PILOTAGE ADVISORY COMMITTEE

Proposed Changes of Navigation Aids for Marking Adamasta Rock

Diagram 2 : Proposed Navigational Aids for Marking Adamasta Rock

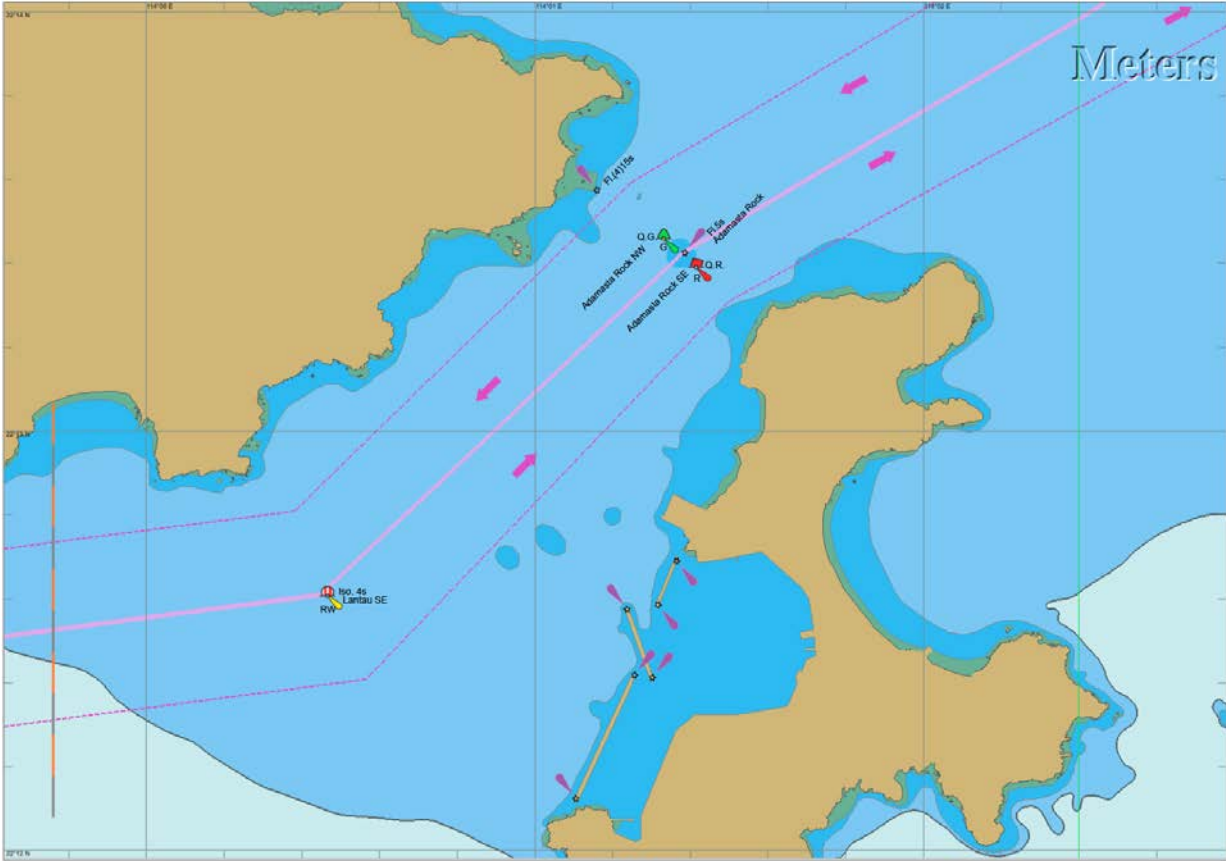
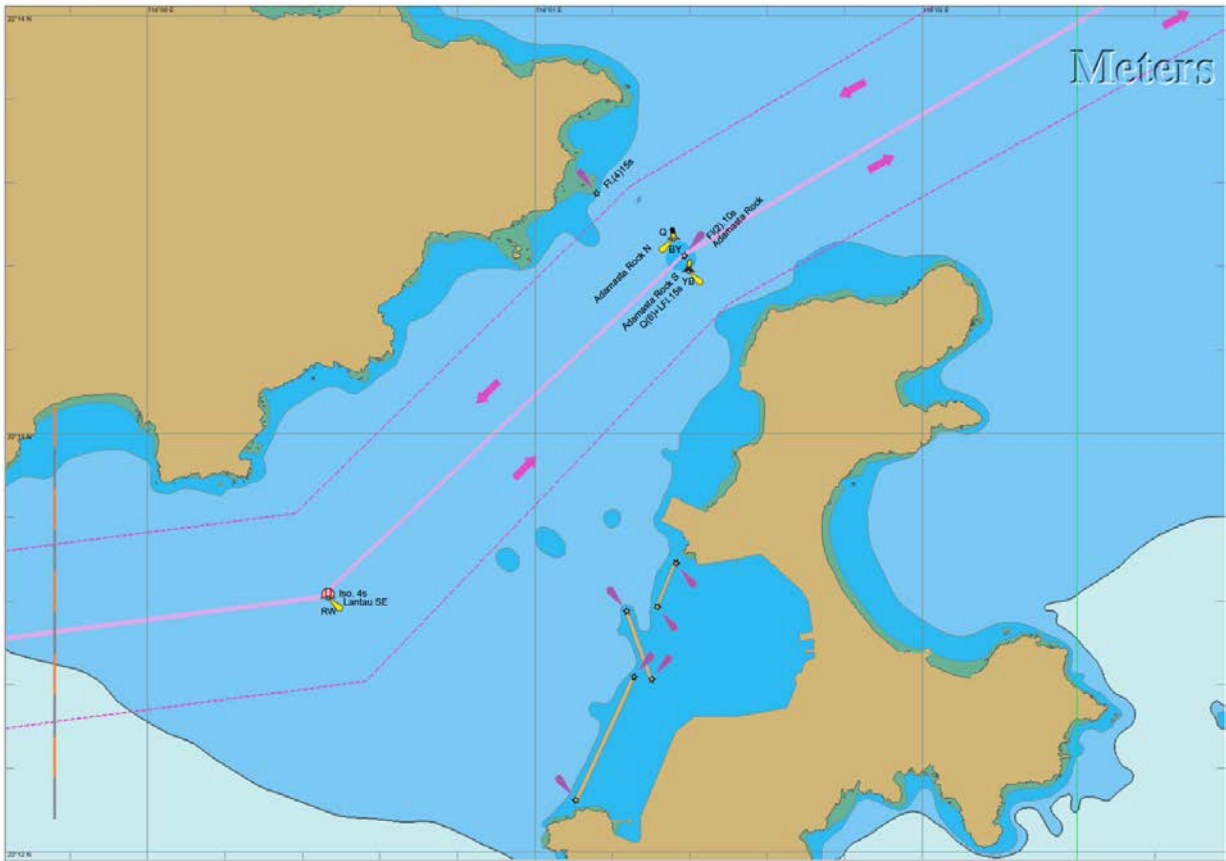
- (i) replacing two existing lateral buoys, currently marking the boundaries of the shoal around Adamasta Rock, by two cardinal buoys at nearby locations (i.e. the northern and southern extremities of the Adamasta Rock shoal) as shown in Diagram 2 below; and
- (ii) changing the light character of the beacon at Adamasta Rock from "Single-flashing" to "Group-flashing (2)", and painting the beacon with black and red horizontal bands.

3. An internal review on the existing navigational aids was conducted for identifying improvements to navigational safety around Adamasta Rock. It is noted that the green conical shape buoy and the red can shape buoy are presented as a pair of lateral buoys laid at the extremities of the Adamasta Rock shoal of about 200 metres apart. As there is a perception that a pair of lateral marks, i.e. the green and red buoys, are laid to mark the two sides of a waterway, mariners who are not familiar with the Conventional Direction of

Buoyage at the Adamasta Channel may consider to travel between the two buoys, in case that they are also not aware of the existence / meaning of the light beacon at Adamasta Rock.

4. Taking consideration of the above findings, the review proposed to replace the existing two lateral buoys by two cardinal buoys² at nearby locations, i.e. a cardinal buoy with northern top mark at position of Latitude 22° 13.47' North, Longitude 114° 01.36' East (in WGS 84 Datum) and a cardinal buoy with southern top mark at position of Latitude 22° 13.38' North, Longitude 114° 01.39' East (in WGS 84 Datum), where are the northern and southern extremities of the Adamasta Rock shoal. The light characters of the proposed northern and southern cardinal buoys are "Quick-flashing" and "Quick-flashing (6) followed by a long-flash" respectively. Given the distance between these two buoys is about 200 metres apart, it is also proposed to indicate more clearly the isolated danger characteristic of the beacon at Adamasta Rock by changing the light character of the beacon to "Group-flashing (2)", and painting the beacon with black and red horizontal bands. The proposed navigational aids for marking Adamasta rock are shown in Diagram 2 below.
